**City of Charlottesville  
Board of Architectural Review  
Staff Report  
November 19, 2024**

**Pre-application Discussion – No action will be taken.**

218 West Market Street, Tax Parcel 330276000

Project: New hotel

218 West Market Street:  
Proposed site plan (from Nov 2024 BAR submittal). Trees to be removed identified from the 2019 site plan.

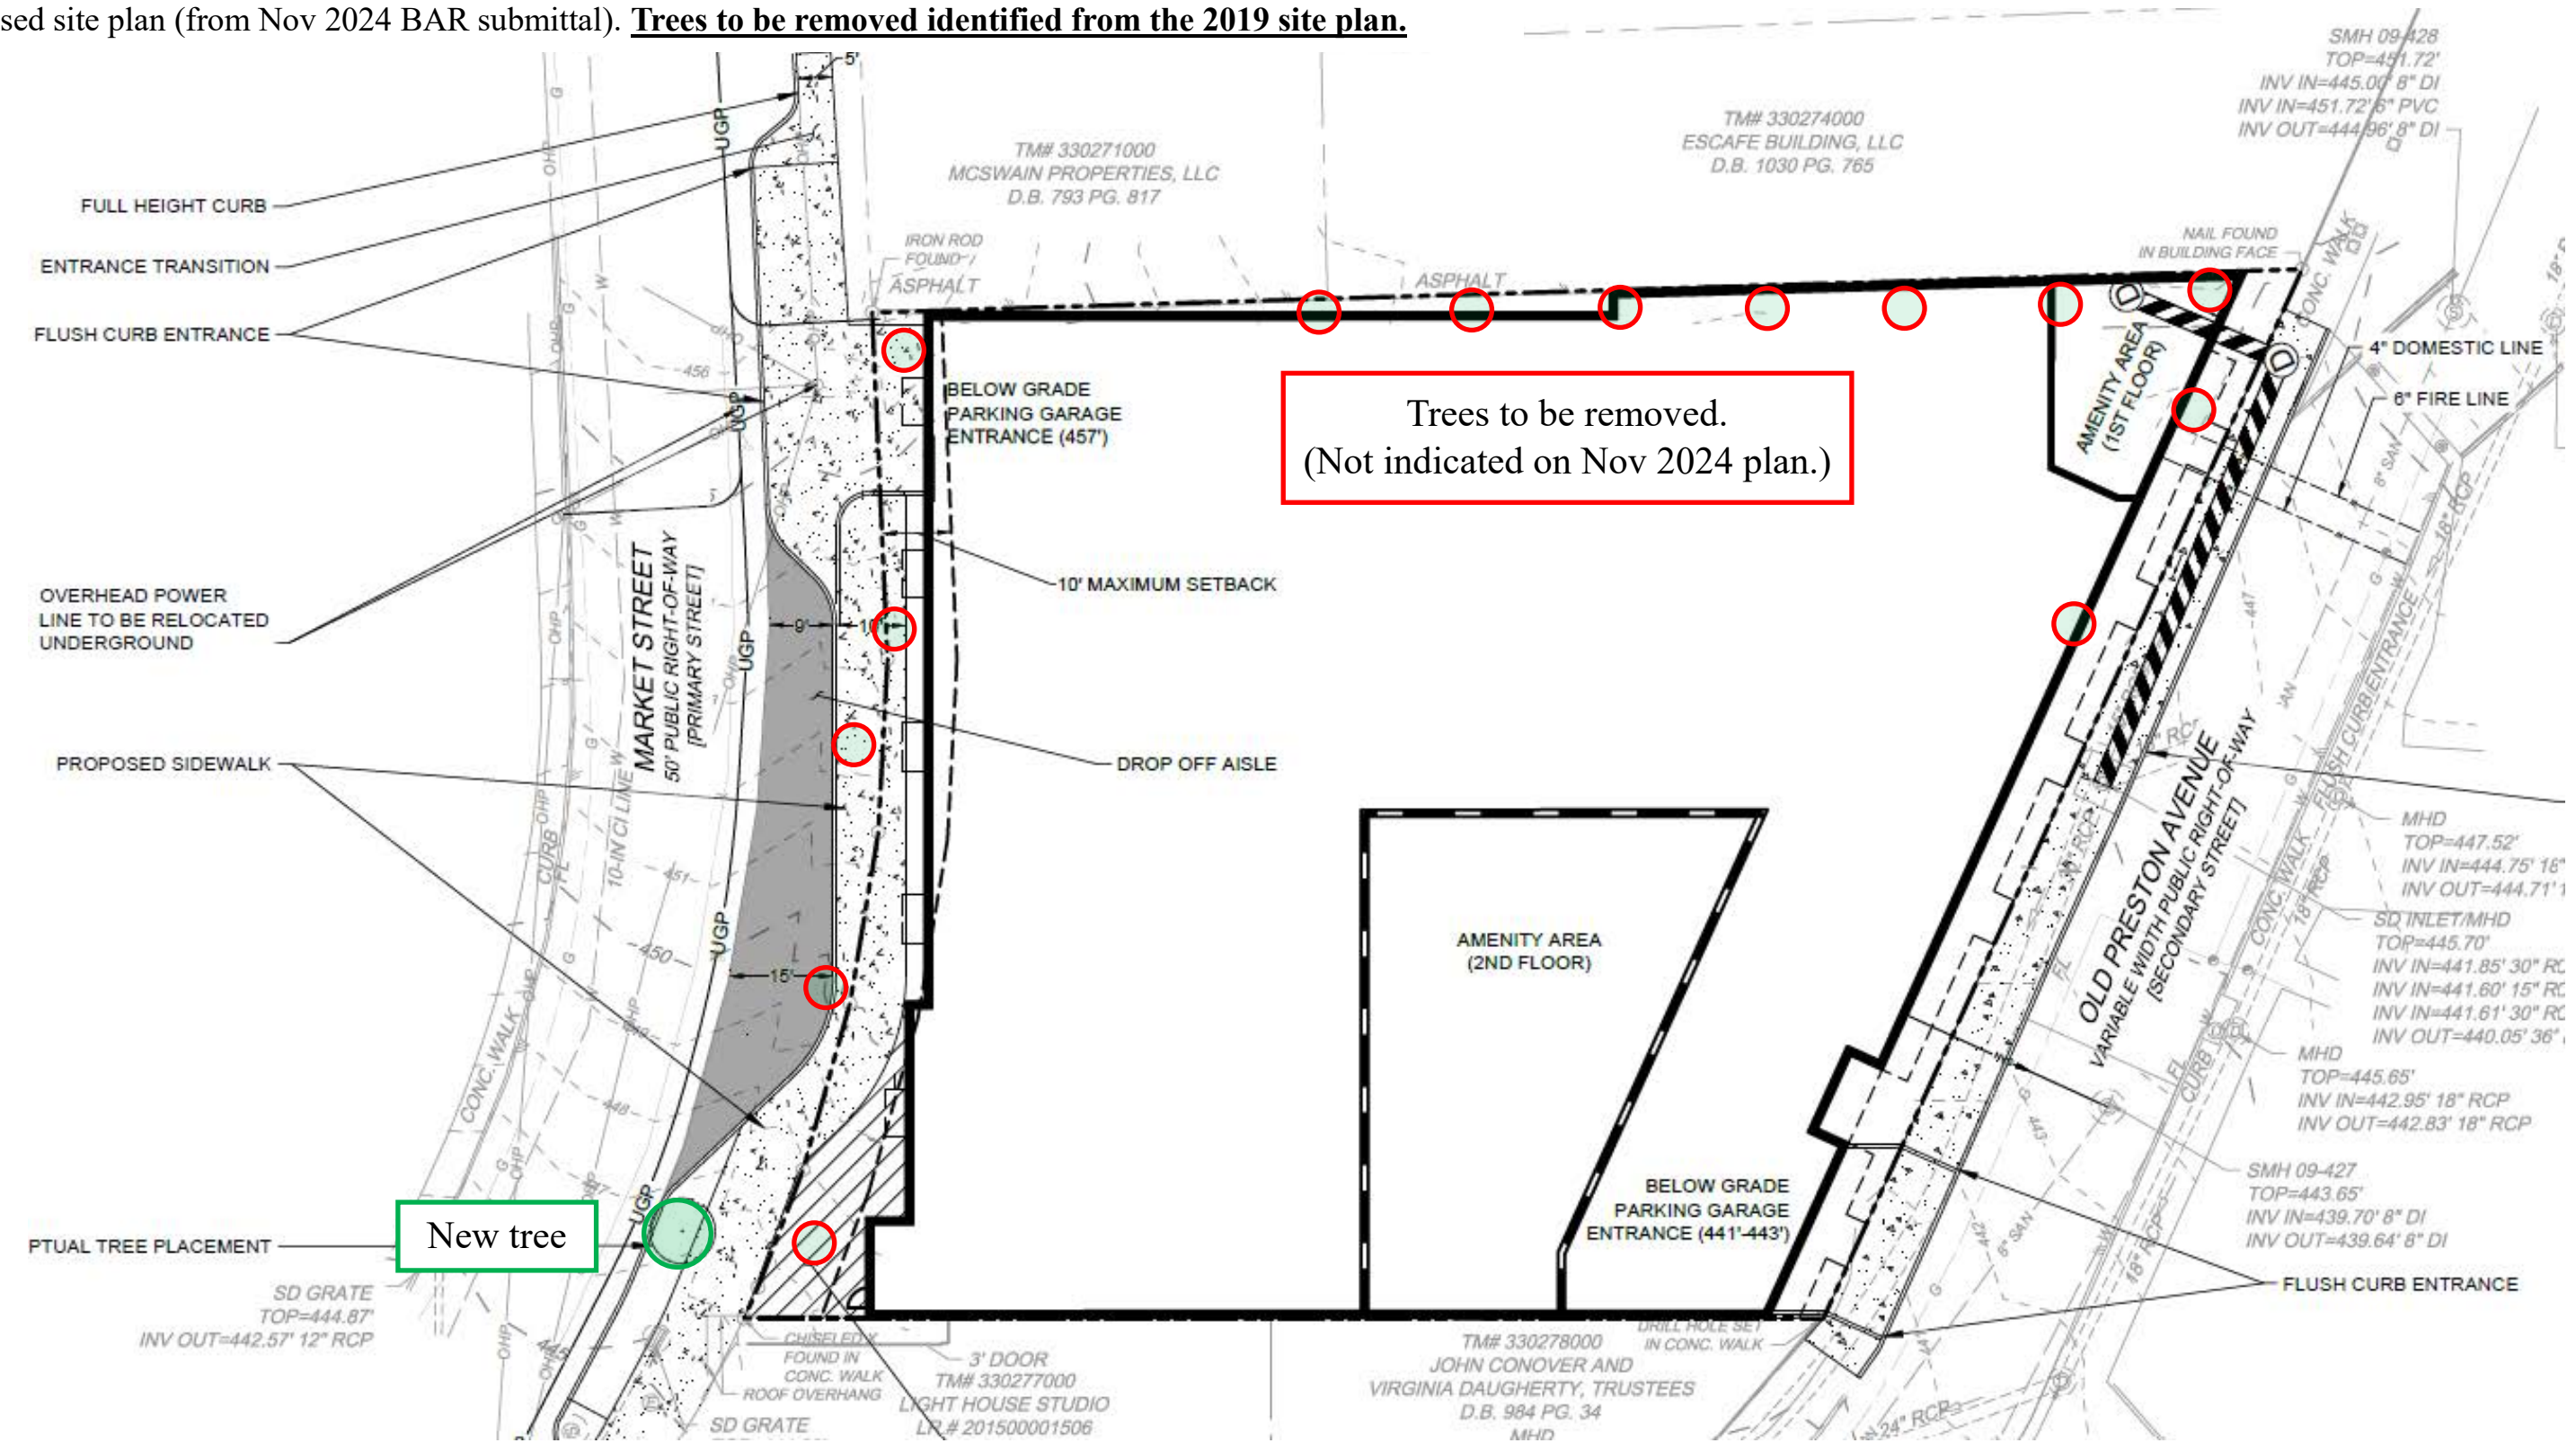
- *When the primary façade [...] is wider than the surrounding historic buildings or the traditional lot size, [modulate] it with bays or varying planes.*
- Provide information re: glass specification.
- Landscaping plan. Project will remove several significant, large trees. (See notes on attached site plans.)
  - *Provide a plan to replace the street trees on site.*
  - *Retain existing trees and plants that help define the character of the district, especially street trees and hedges.*
  - *When constructing new buildings, identify and take care to protect significant existing trees and other plantings.*
- Does the *street-level design* meet the guidelines?
  - *should not have blank walls; they should provide visual interest to the passing pedestrian.*
- Show rooftop mechanical screening. Location, material.

- The building's massing will be broken up to provide compatibility with the character-defining features of the historic district.
- Provide adequate protection of adjacent historic structures.
- Provide a plan to replace the street trees on site.
- Improve pedestrian character of Old Preston and Market Street
- Provide pedestrian through access between Market Street and Old Preston.

SOUTH SIDE ELEVATION  
(OLD PRESTON AVENUE)

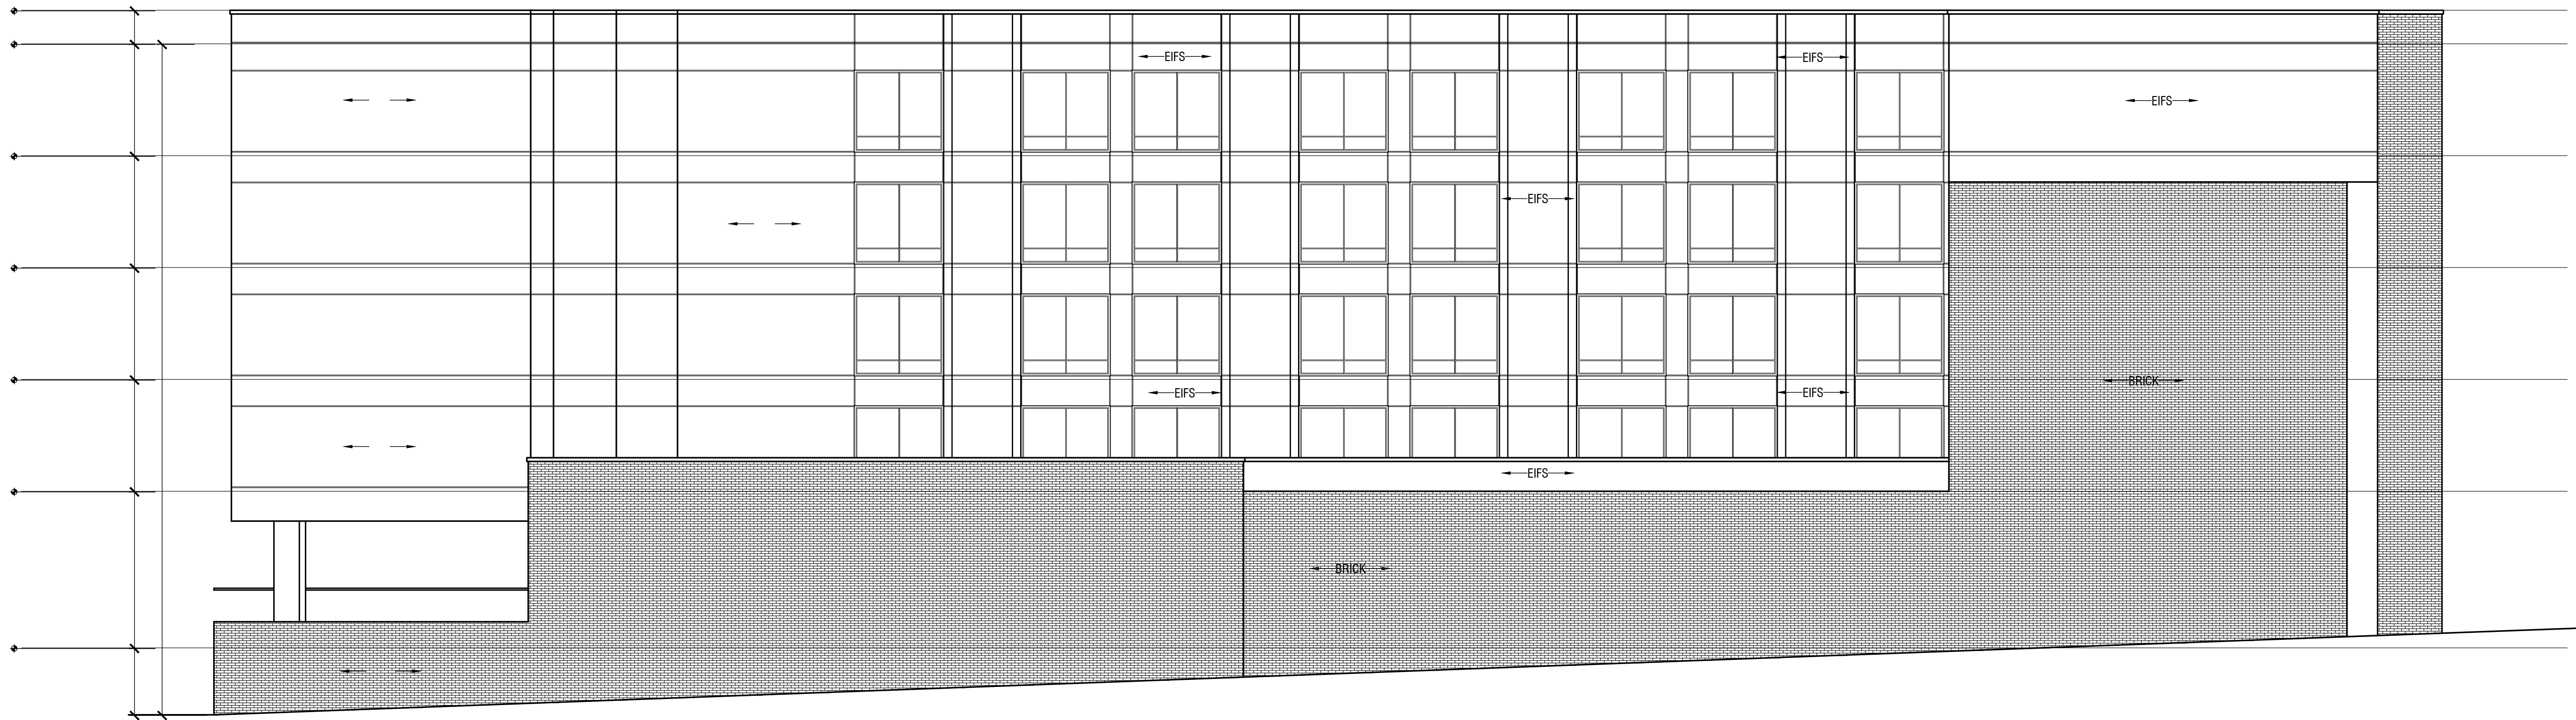
- At Preston Avenue, brick pavers are shown at the sidewalk and at the building. Is it appropriate to continue the Mall brick (type, size, pattern, etc.)? Is it appropriate to transition the Mall brick pavers to the paving on the parcel? [Note: *Extension* of the Mall brick may require a policy level discussion, and not necessarily be within the BAR’s purview.)

- Is the vertical wood siding appropriate? Is it appropriate to have the appearance\* of stained wood? Guidelines require painted wood. (\*Staff assumes this will be a metal product.)
